REPORT OF OBSERVATION AND EVALUATION

VANERT RESIDENCE
536 LAKESIDE LN
SANFORD, NC

I OBSERVED CONSTRUCTION OF GARAGE ADDITION ON THIS DATE.

Addition of Garage

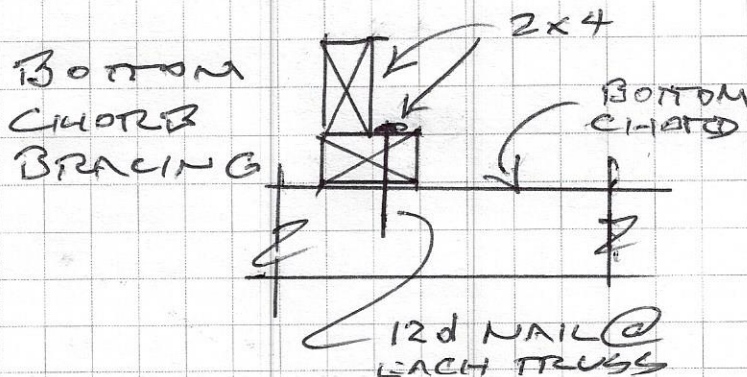
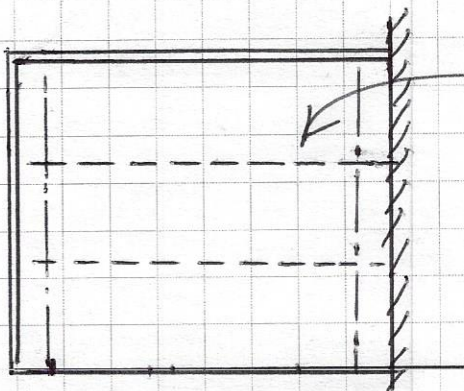
1. GABLE TRUSS BEARING ADEQUATE.
2. REMOVE/REPLACE BRICK VENEER AS SHOWN IN DETAIL B.
3. INSTALL DOUBLE TOP PL AND HEADER AT WINDOWS AS SHOWN IN DETAIL A.
4. ADD STRAP TO POST AS SHOWN IN DETAIL C.
5. ADD 2 LINES OF BRACING @ BOTTOM CHORD OF ROOF TRUSSES AS SHOWN BELOW
6. FOOTING PROJECTION / DEPTH ADEQUATE.
